OFFICE RENOVATION & DOCK ADDITION: OLD DOMINION FREIGHT LINE ODFL PORTLAND, ME 185 RAND ROAD PORTLAND, ME 04102

SITE LIGHTING CHG 5/21/14

REVIEW COMMENTS 6/10/14

Sheet Name: SITE PHOTOMETRICS
Sheet Number:

SITE PHOTOMETRICS PLAN

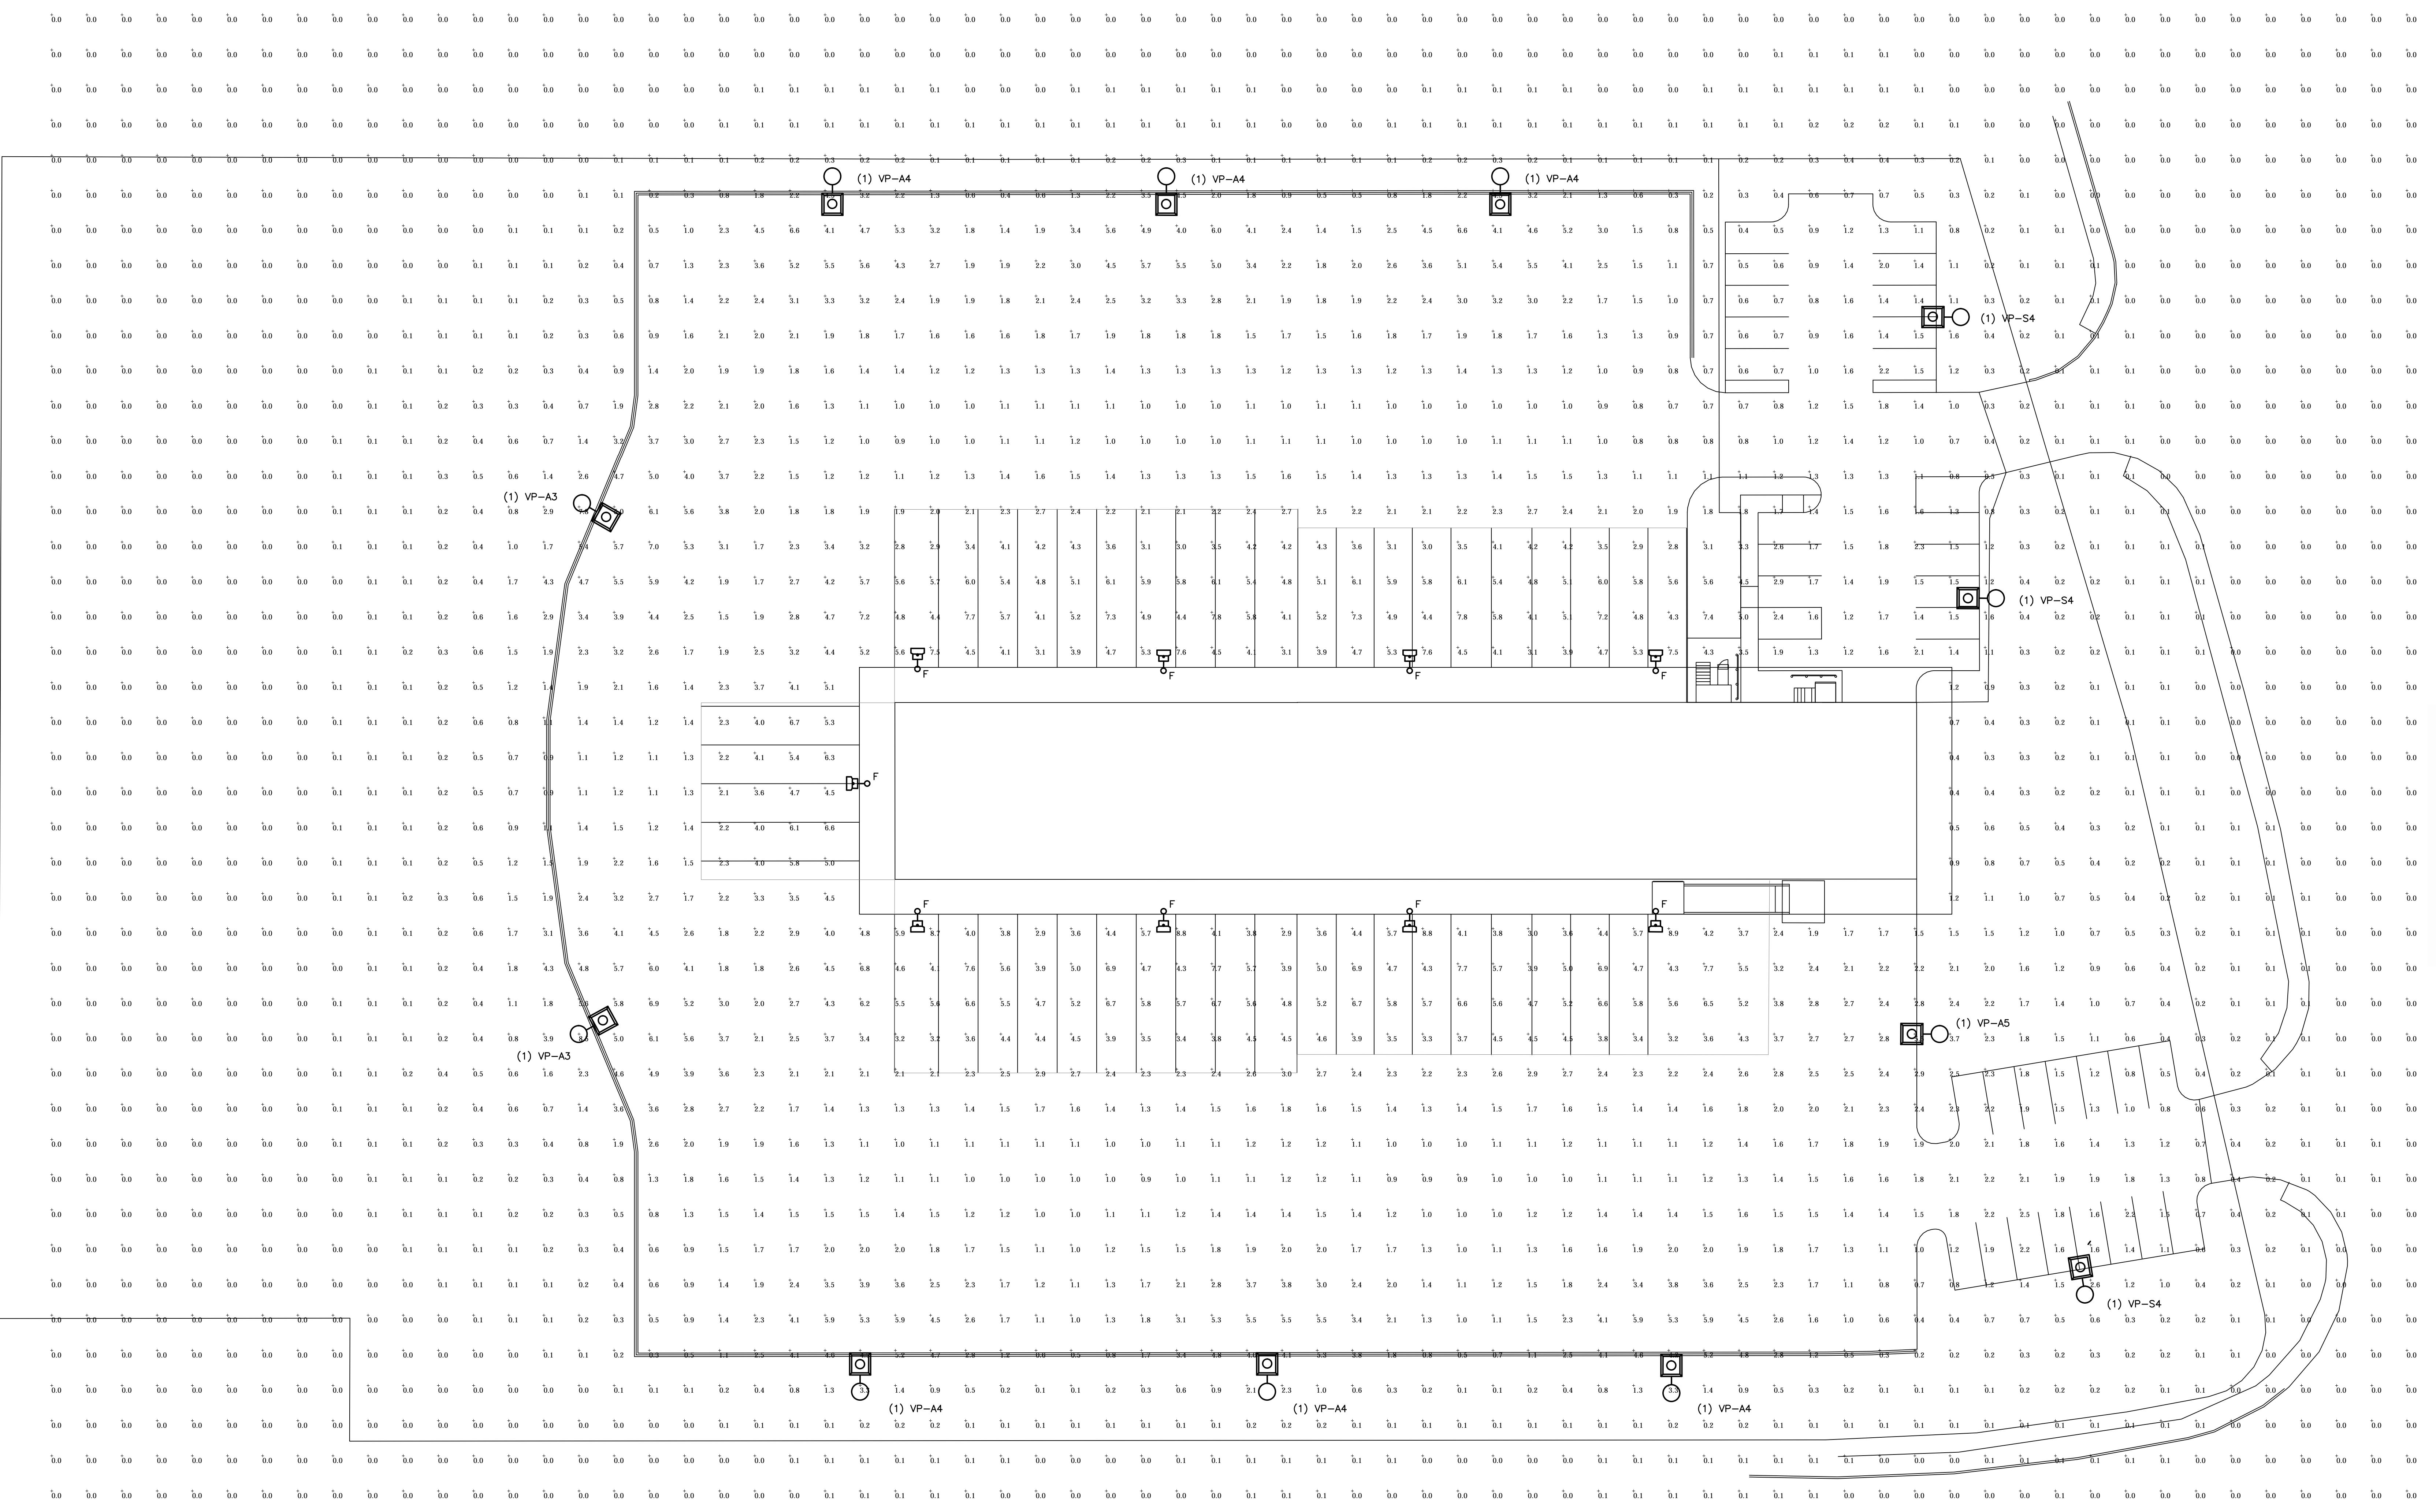
NEW PHOTOMETRICS CALCULATIONS BASED ON NEW SITE LIGHTING LAYOUT.
